Legacy Holladay Park Central Lab

LUR 13-139304 DZM PR

Proposal for a Clinical Laboratory
for Legacy Health
Two floors, 31,000 sq ft each

Response to Design Commission Comments **Design Review Hearing July 11, 2013**

Wayfinding / Entrance NE 2nd and Wasco

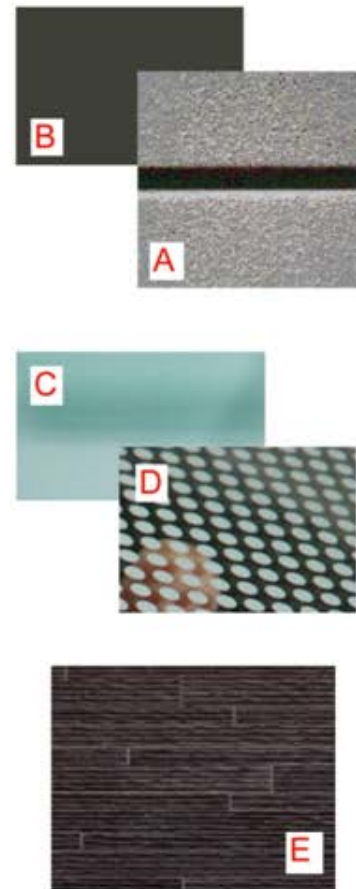
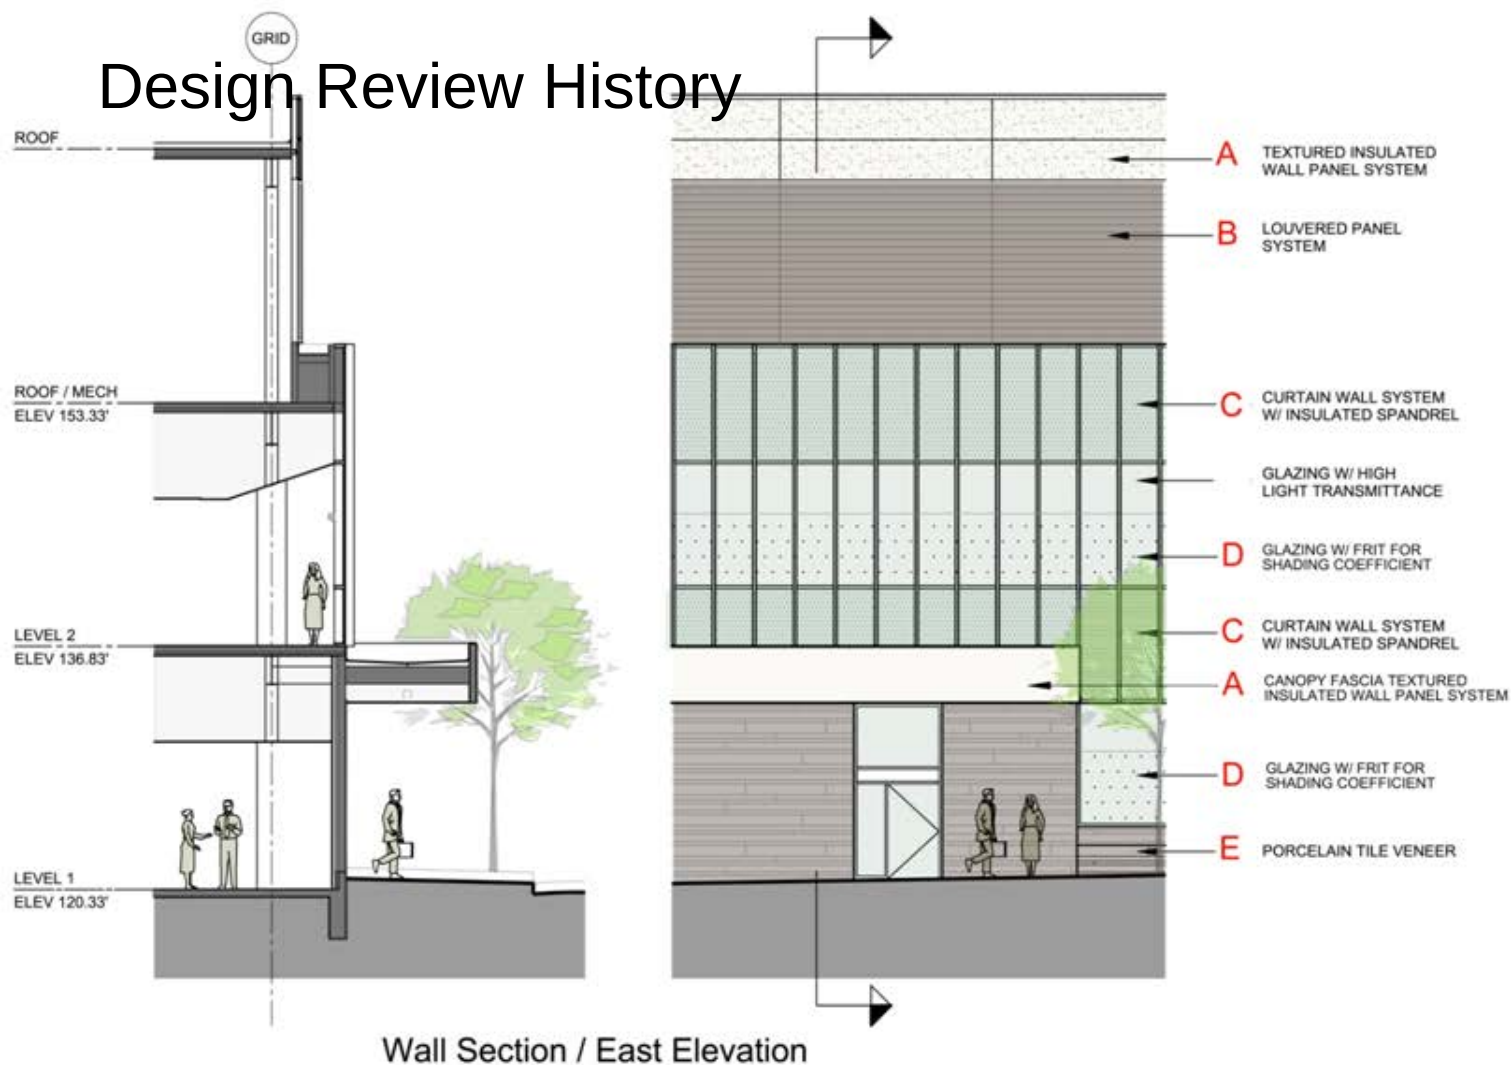
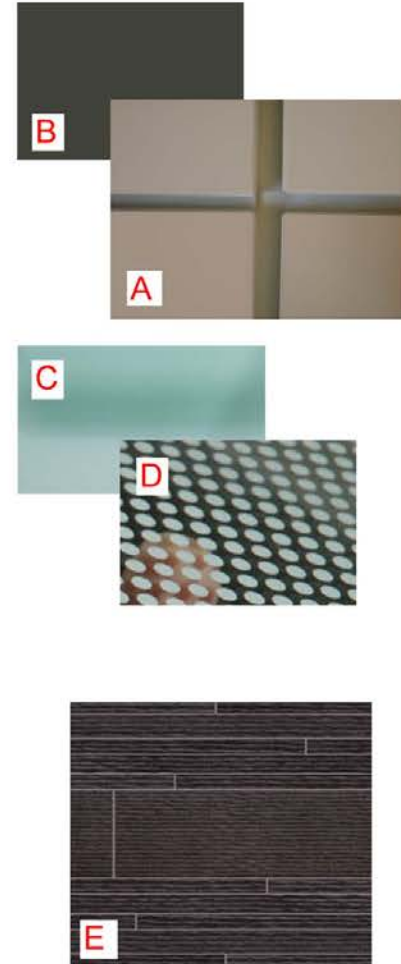
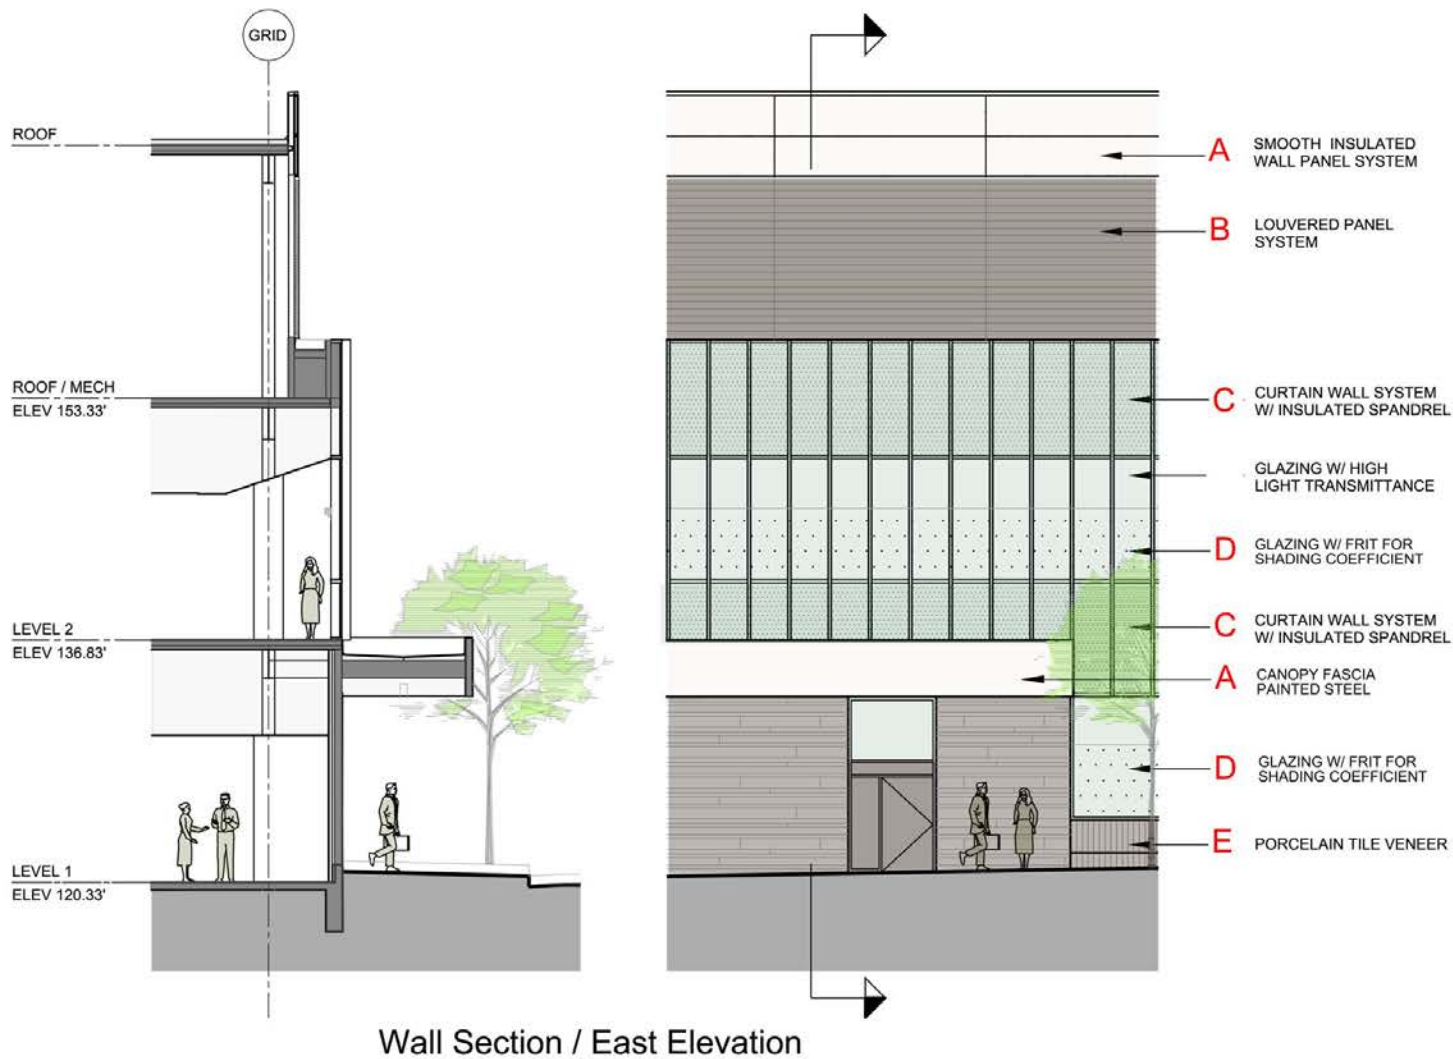
- 'Staff Only' Door
- Walled Garden at Main Entry
- Sill Height at 'Lantern'

Metal Panel Texture and Color

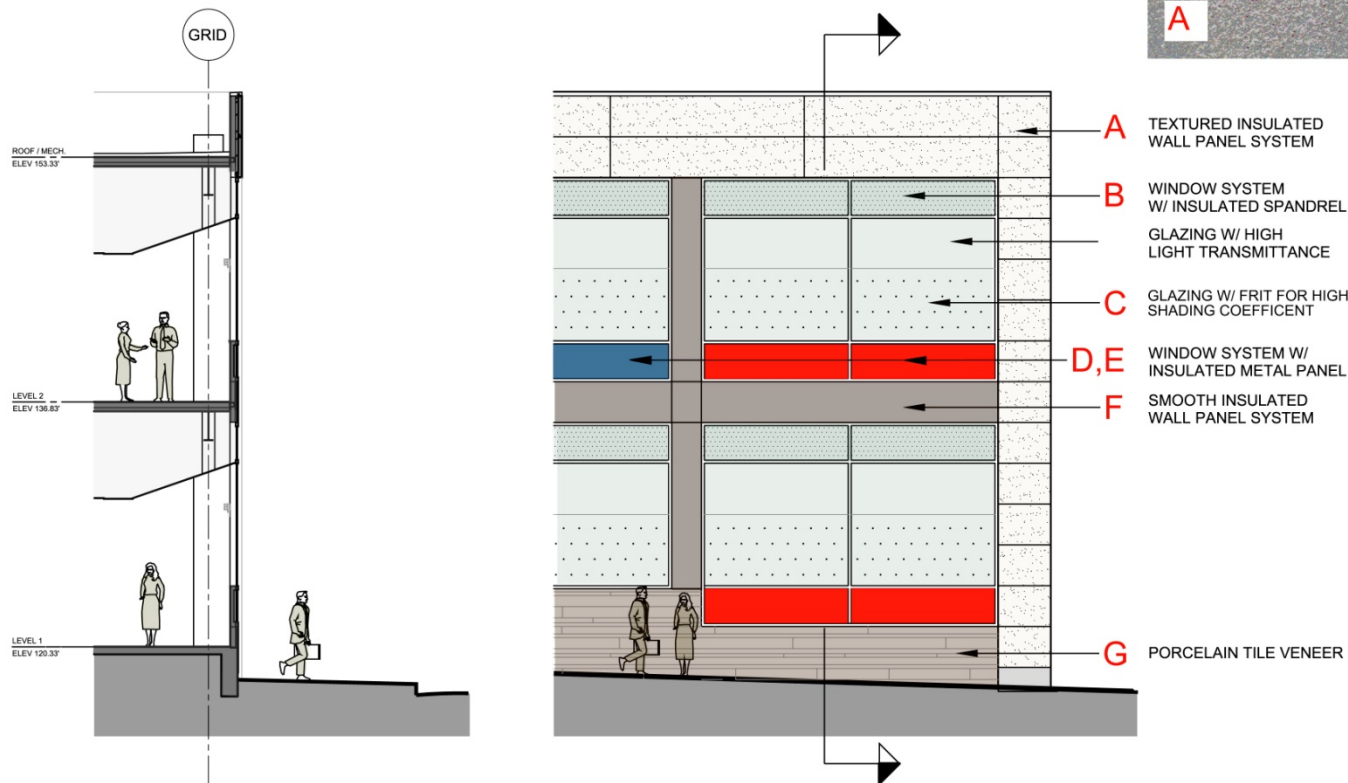
- Metal Panel Texture
- Colored Accent Panels

Tile Pattern and Corner Detail

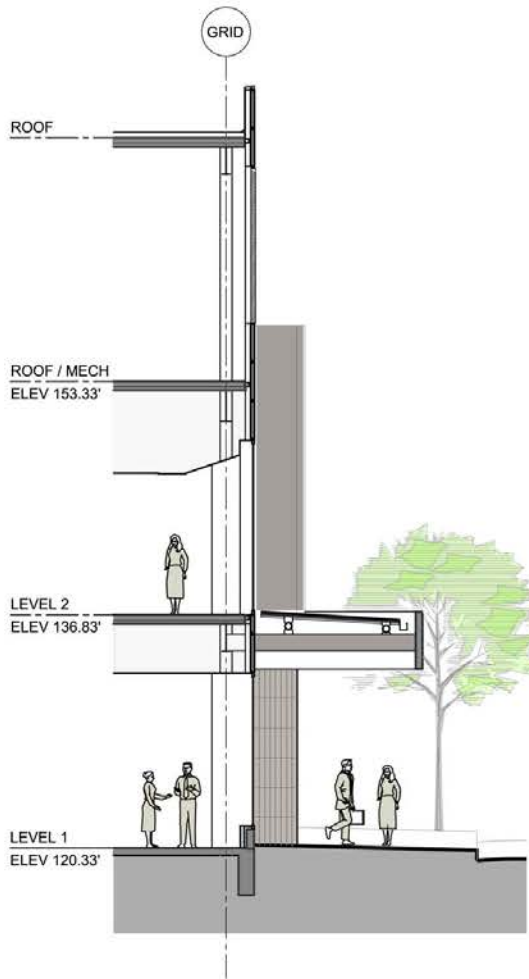
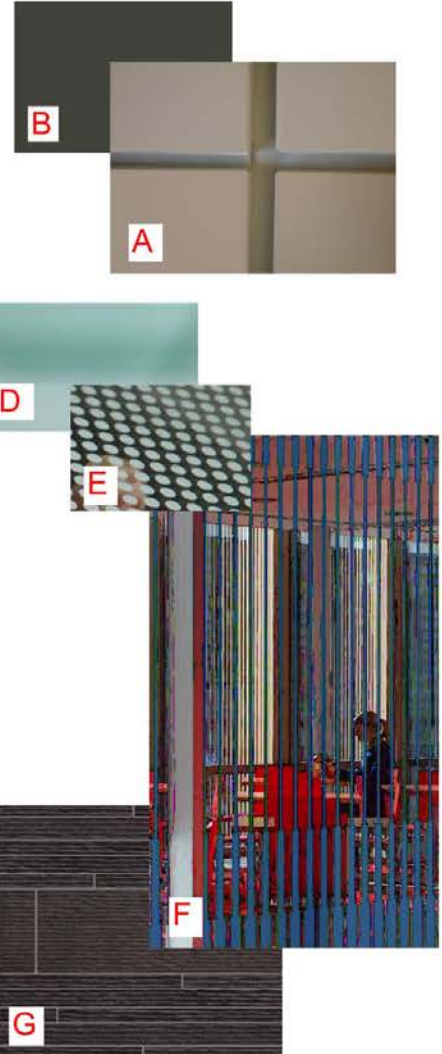
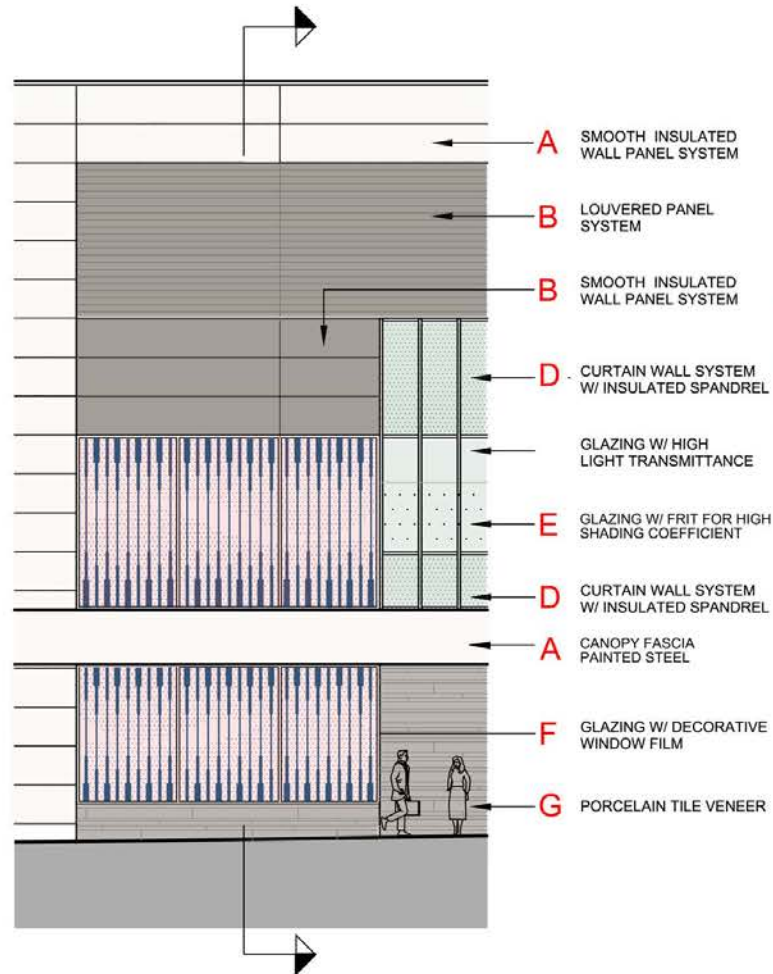
- Scale and Pattern of Tile
- Corner Detail

Landscaping

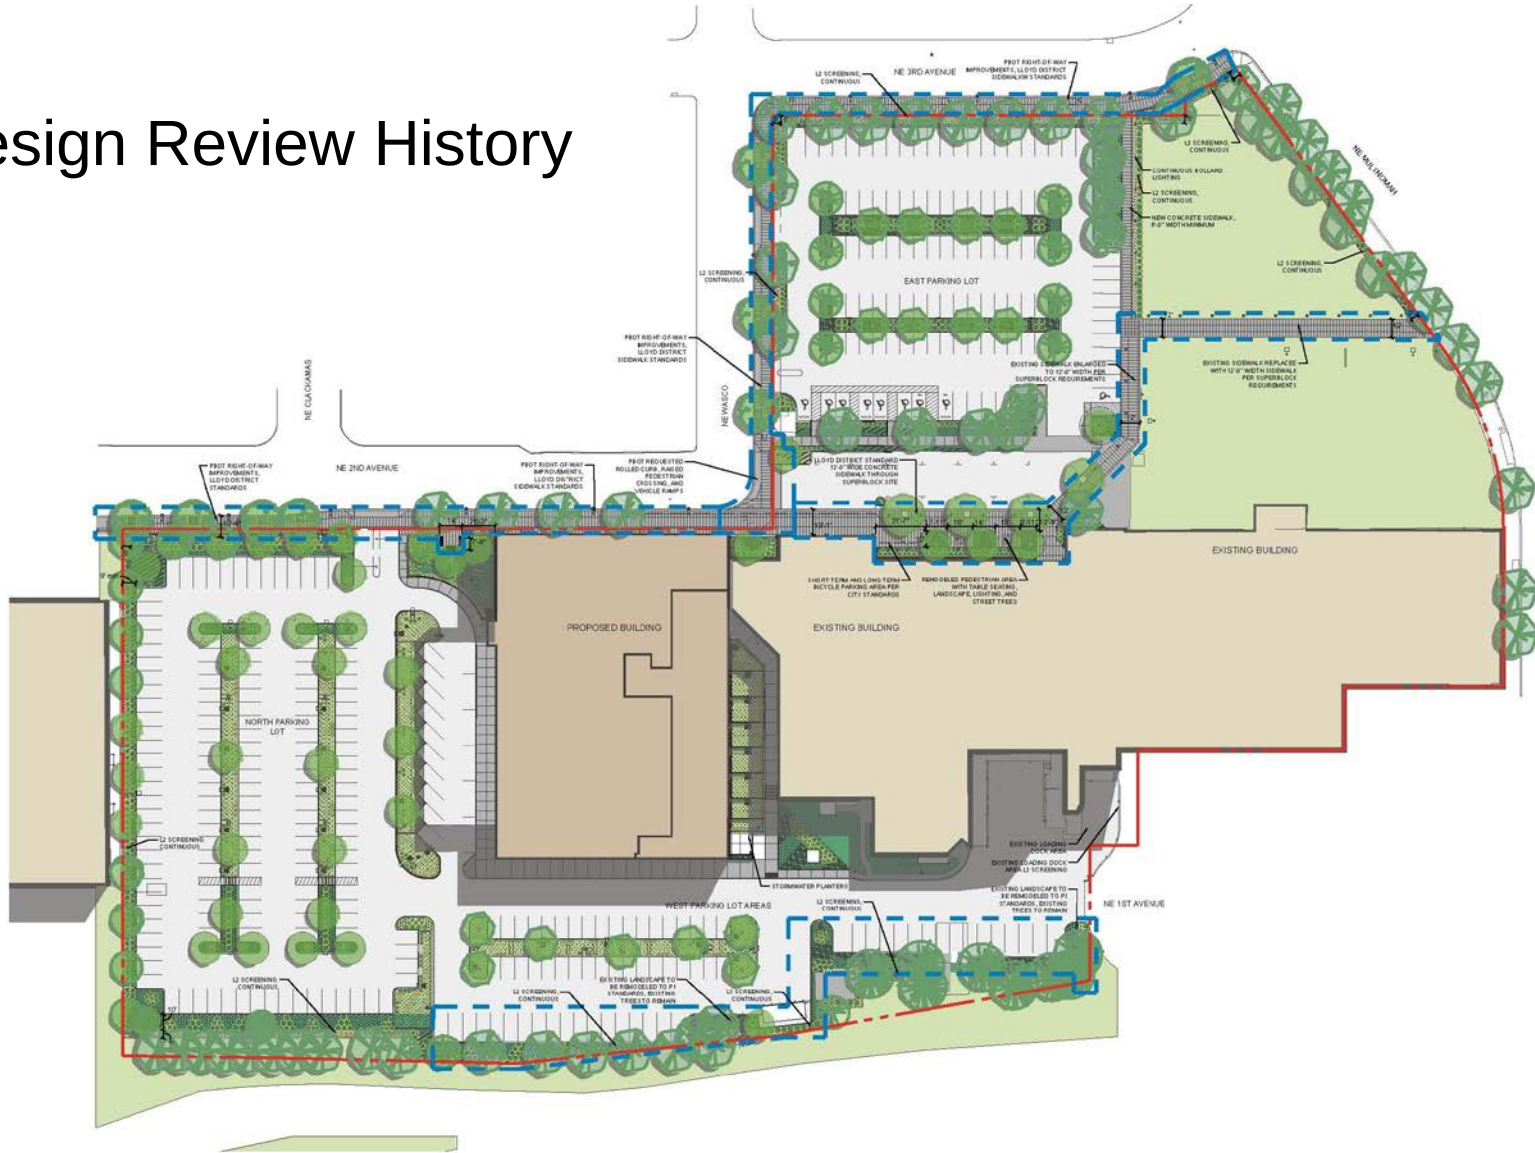
- North Landscape Planter/ Respite Area
- Existing Plaza Upgrades
- Existing Parking Landscaping NE 2nd
